# **Plan Changes 93-94**

## **Summary of Proposed Changes from the Section 32 Reports**

## **Plan Change 93**

# **Te Puna Springs – Expand Commercial Zone**

## 8. Te Puna Springs

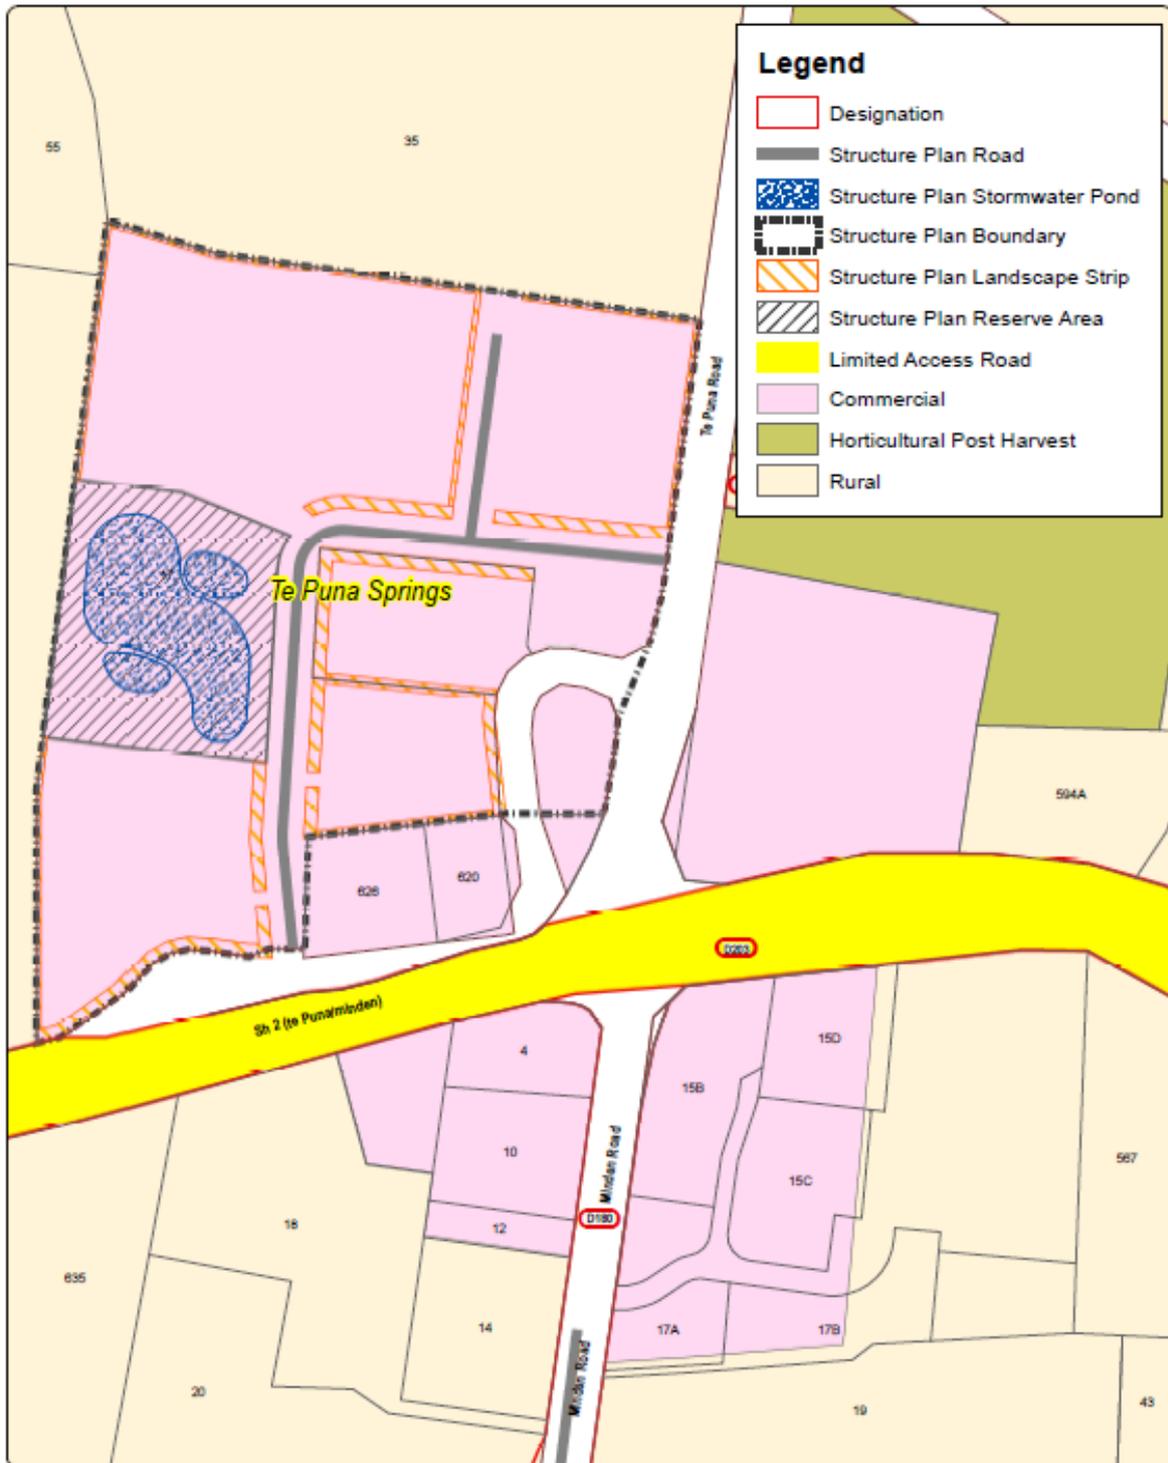
**Rezone 17 Te Puna Road, Te Puna, from Rural/Commercial split zone to Commercial and insert Structure Plan (including boundary and features) by making the following changes to Appendix 7 – Structures Plans and the Planning Maps.**

## 12.1 Washer Road Business Park – Staging Plan

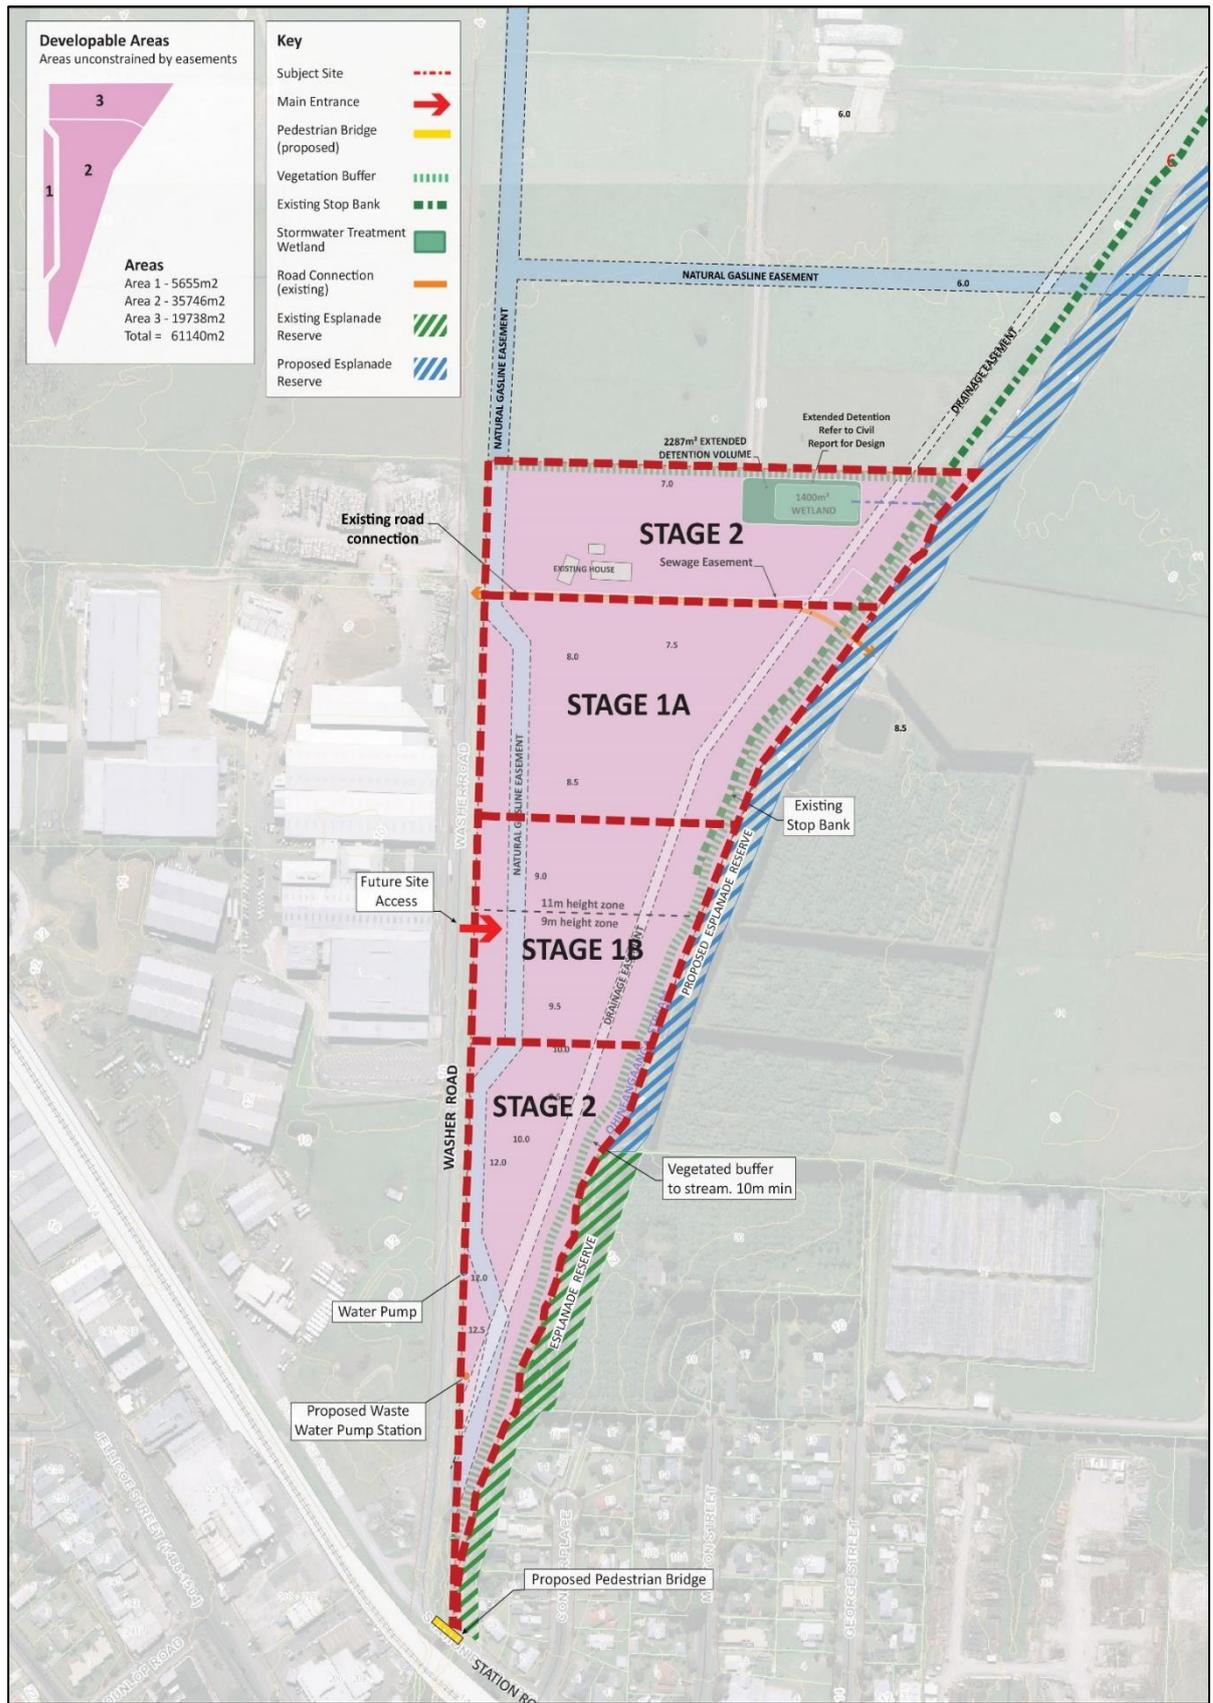
**Rezone 66 Washer Road, Te Puke, from Rural to Industrial and insert Structure Plan (including boundary and features) by making the following changes to Appendix 7 – Structures Plans and the Planning Maps**

The following Staging is required for Washer Road Business Park to enable the site to be developed progressively. Earthworks and preloading of the site are required to prepare the land for future industrial use. Subdivision and development shall not occur within a stage until all required works are completed for that stage and any previous stages.

### Stage 1A – Infrastructure Works

- Sewer pump station and rising main
- Stormwater pond (extended detention)
- Water supply
- Landscape buffer adjacent to Stage 1A

### Stage 1B – Infrastructure Works

- Washer Road seal widening
- Form primary road entrance to industrial land
- Pedestrian bridge over Ohineangaanga Stream
- Landscape buffer adjacent to Stage 1B
